Landscape Rehabilitation

Final Design Report

Apache Junction Floodway & FRS
Apache Junction Outlet & Bulldog Floodway

**Final Review
Comments and Responses**

Designed by JD	Date 4/87	Approved by	
Drawn by JD	Date 4/87	Traced	
Checked by JD	Date 4/87	Sheet No 12 of 14	Drawing No L-11

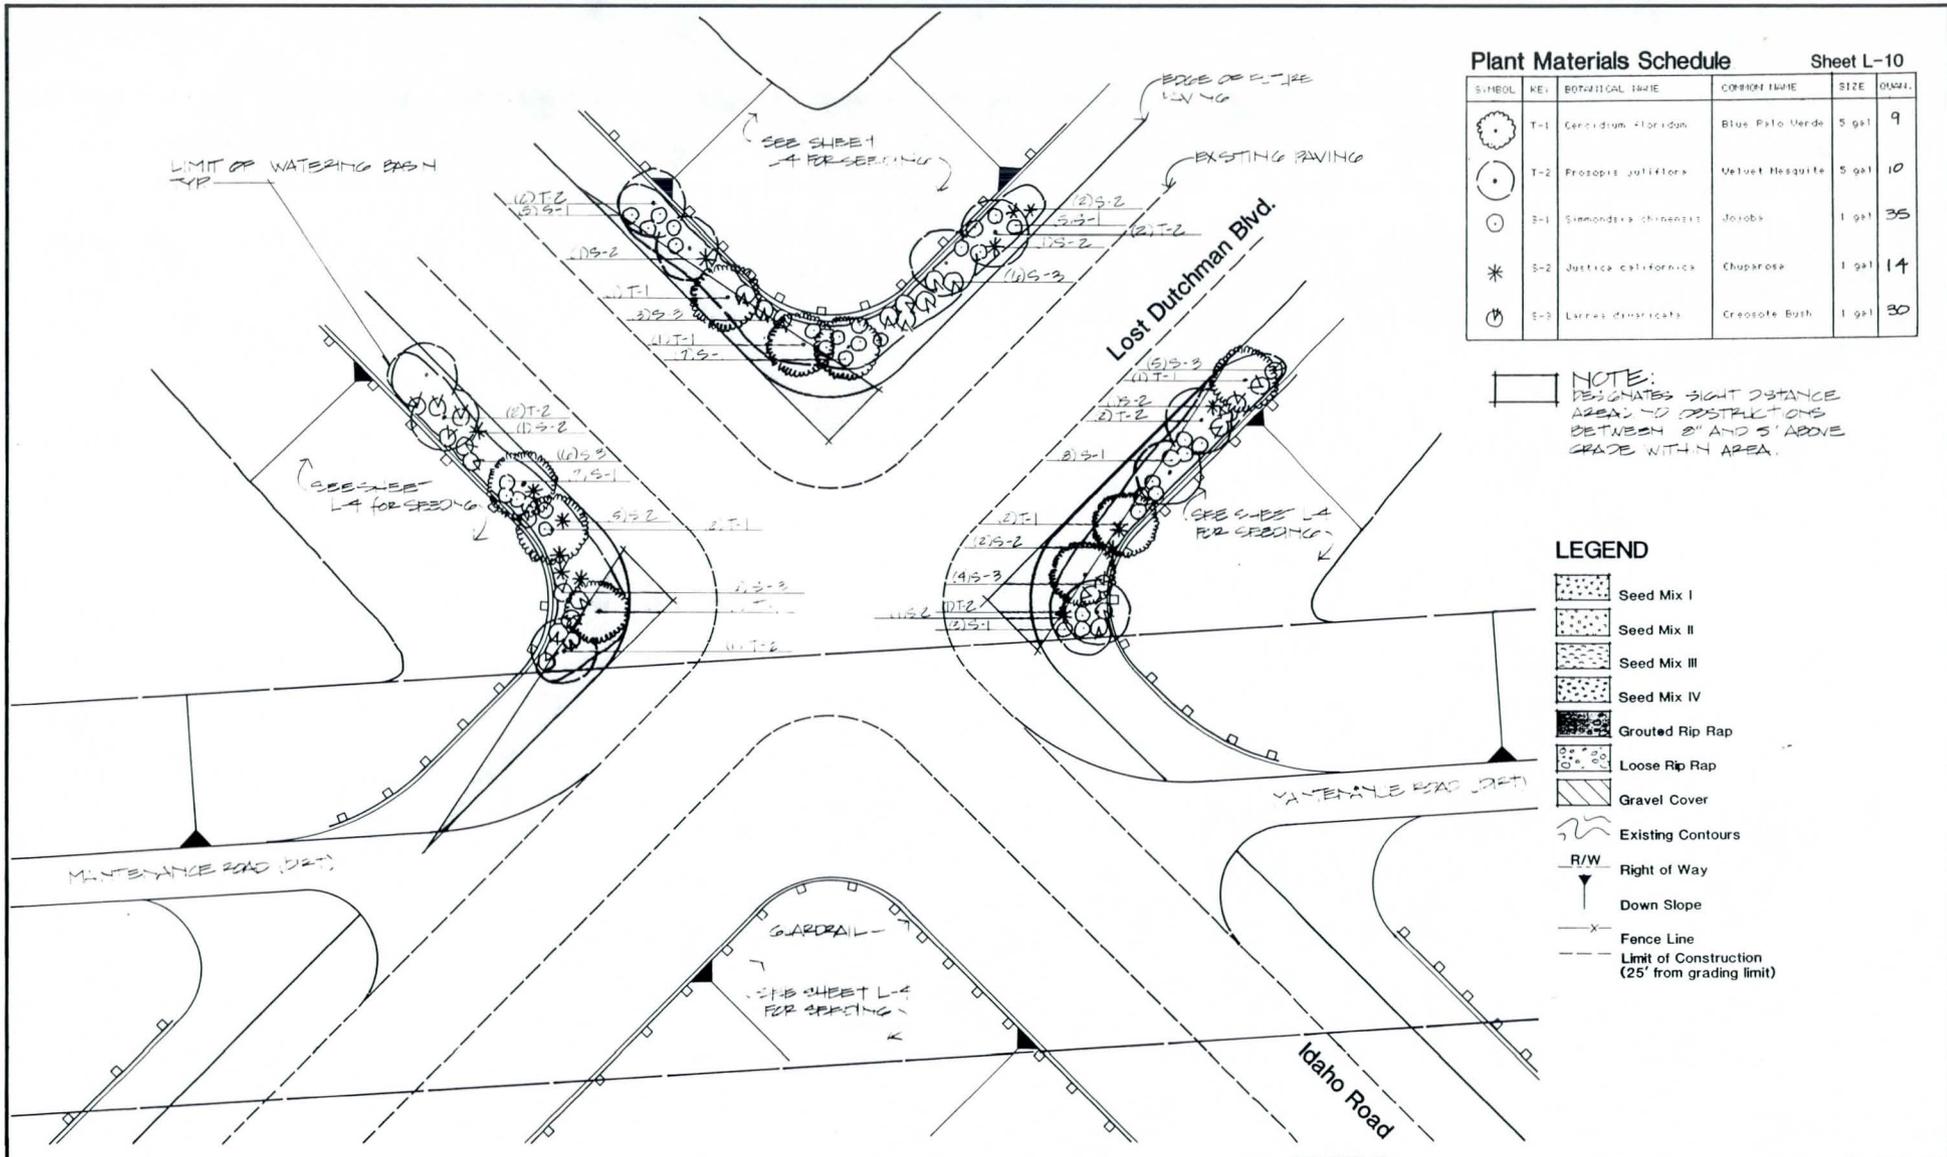
1. The drawings do not show the limits and type of seed mix in the borrow area between station 74+00 and station 80+00. Also, is there any special treatment or plantings planned in the vicinity of the large culverts under Idaho Road and Lost Dutchman Boulevard in this same reach?

1. The drawing on this page reflects incorrect plant counts.
 - a. For the southeast quadrant between Idaho Road and Lost Dutchman, shrub #3 (S-3) shows a count of 58; the correct count is 57.

- b. In the center of the page shrub #2 (S-2) shows a count of 13, the correct count is 12.
2.
 - a. In the Plant Materials Schedule S-1 **Simmondsia chinensis** shows a count of 92; the correct count is 63.

3. It is our view that the roadway nodes are overplanted. Plant densities should be decreased by approximately one-half. Without benefit of permanent, automated irrigation system, or an extensive passive water harvesting system, competition for limited rainfall and runoff will drastically reduce the number of healthy, viable plants. Jojoba and chuparosa, because of their higher water requirements, will be particularly affected.

1. The area referred to is at the Idaho/Lost Dutchman road crossing over the FRS. We have shown this area on our new sheet L-4 (seeding and gravel cover) and sheet L-11 (container planting). No special treatment is planned for the vicinity of

the culverts. Seed Mix Type IV, which includes mesquite, will be applied in this area. The mesquites will provide the necessary screening as they mature. This area is not regarded as a high priority area as it is hidden behind the FRS.

C. Page L-10 (now Page L-11)

1. We have double checked the plant counts on our latest design for this area.
2. Plant counts have been checked and corrected.
3. The plant densities for all road crossings are similar to those provided on the plans for the Pass Mountain/Signal Butte structures.

PLANTING PLAN
 Floodway Crossings at Ironwood
 and Meridian Roads

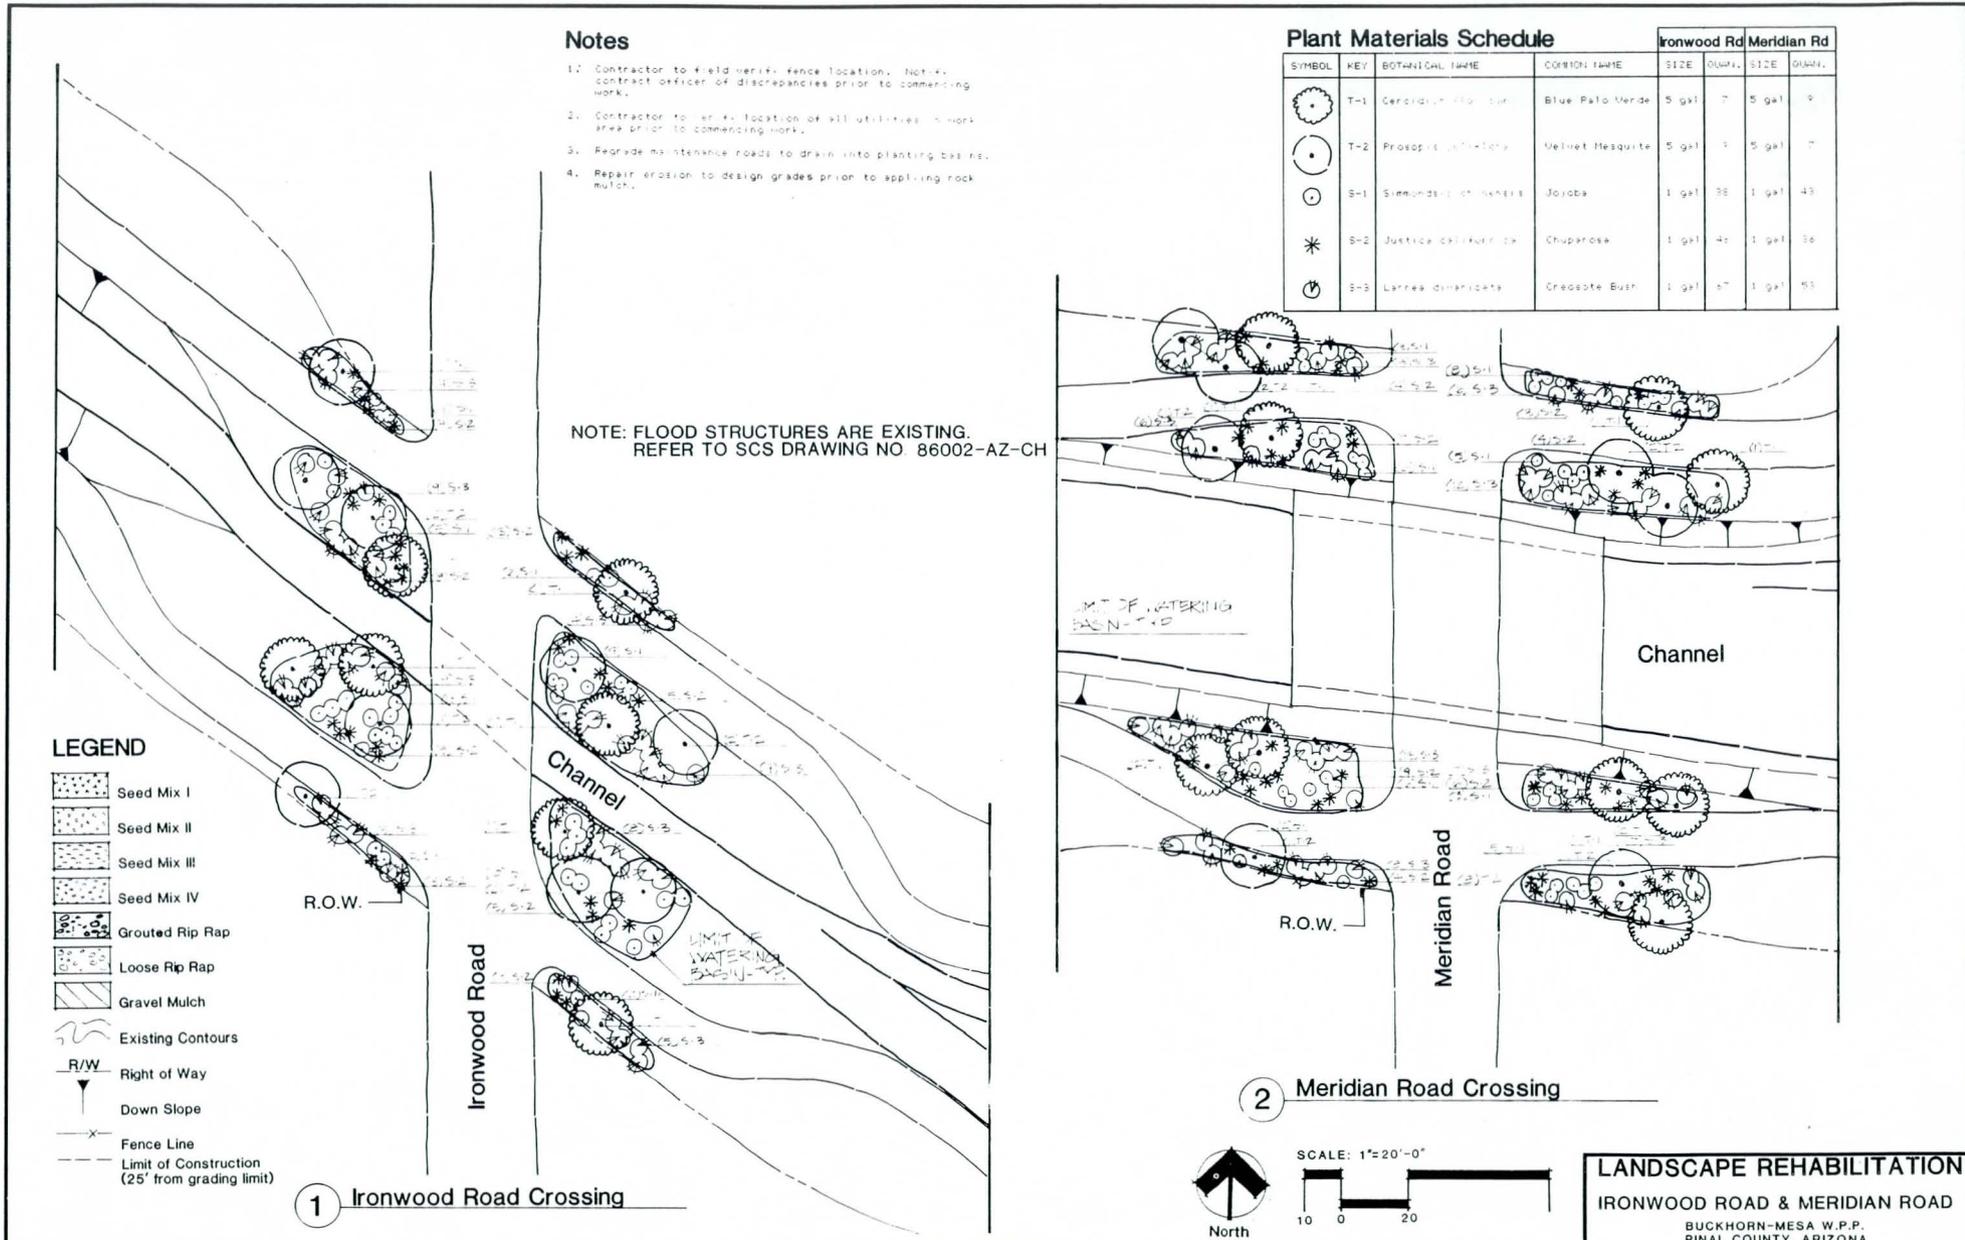
16. p. L-11--Note at top of page indicates the contractor is to verify fence location. No fencing is indicated on drawing.

1. The comment under item 3, p. L-10, applies here as well. A passive water harvesting system, utilizing a specific grading plan designed to collect and concentrate naturally occurring runoff would greatly improve the success, aesthetics, and effectiveness of these planting nodes.
2. Detail 2 in the approximate center of Meridian Road: shrub #2, **Justicia californica**, shows a count of 9; the correct count is 10.
3. Plant Materials Schedule shows shrub #2, **Justicia californica**, shows a count of 46; the correct count is 47.

- c. Fencing has been deleted from all container planting plans as it is not affected by planting.

D. Page L-11 (now Page L-12)

1. Grading information in the form of drainage arrows and basin limit lines has been provided for all container planting plans.
2. All plant counts have been checked and corrected.

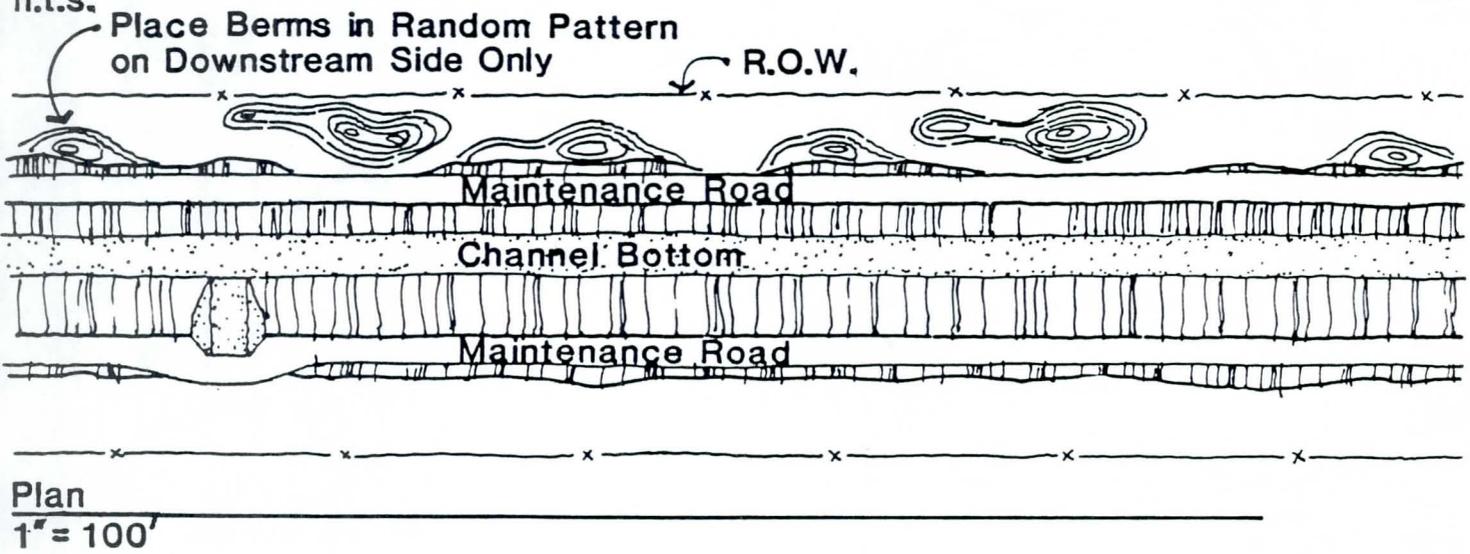
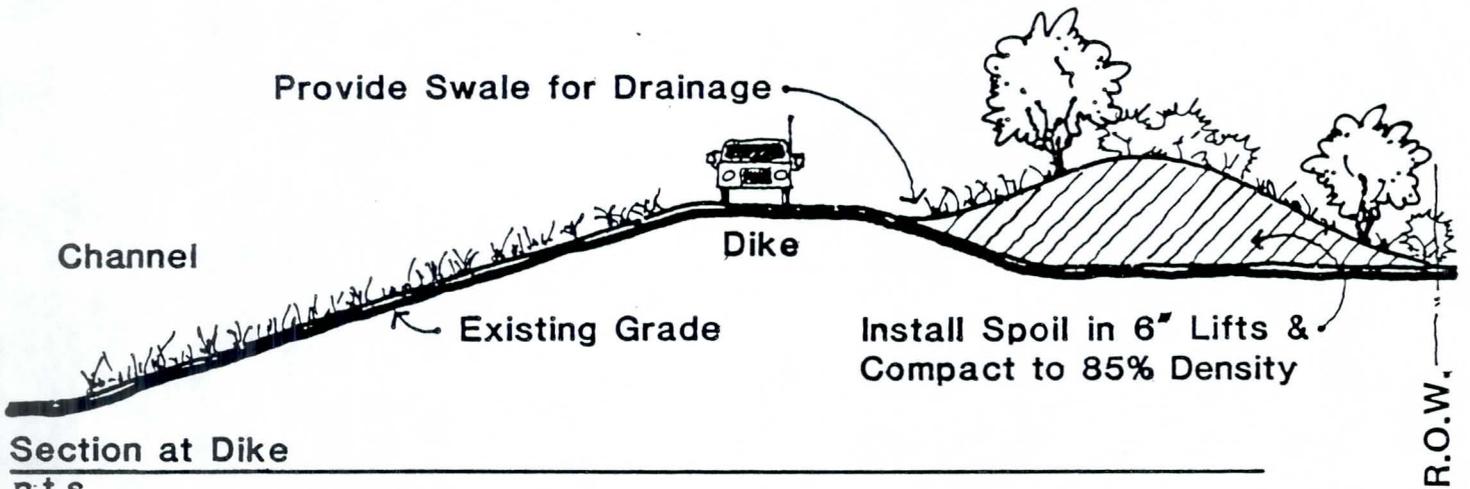
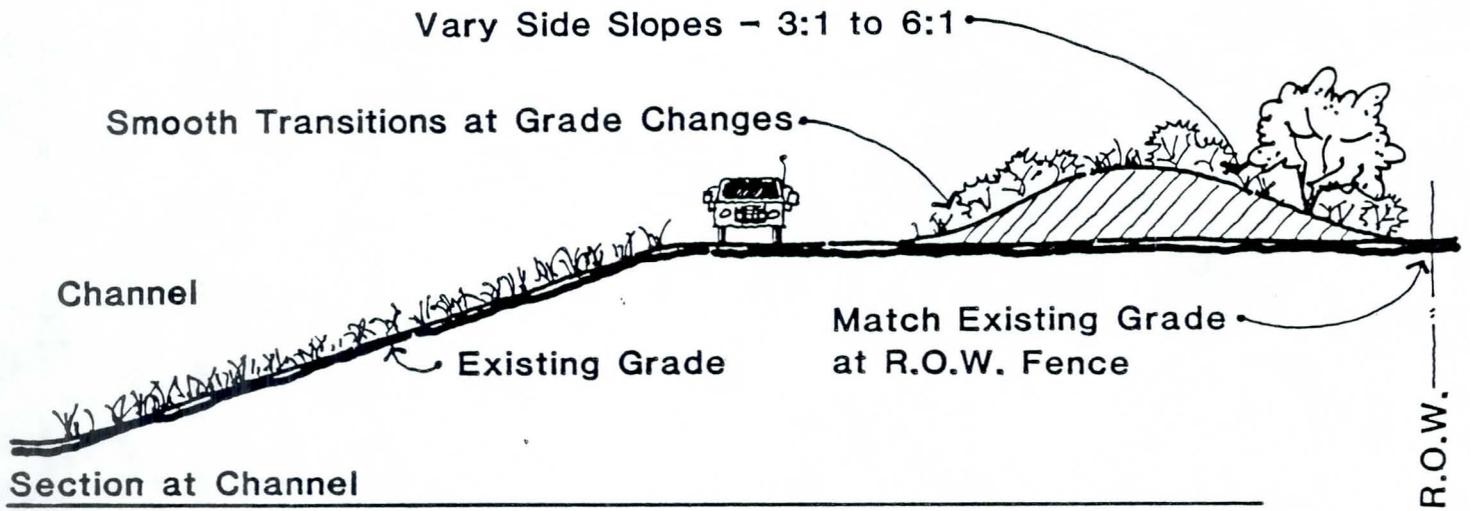
How can you get soil from channel bottoms and energy dissipators? The channel is completed to finish grade.
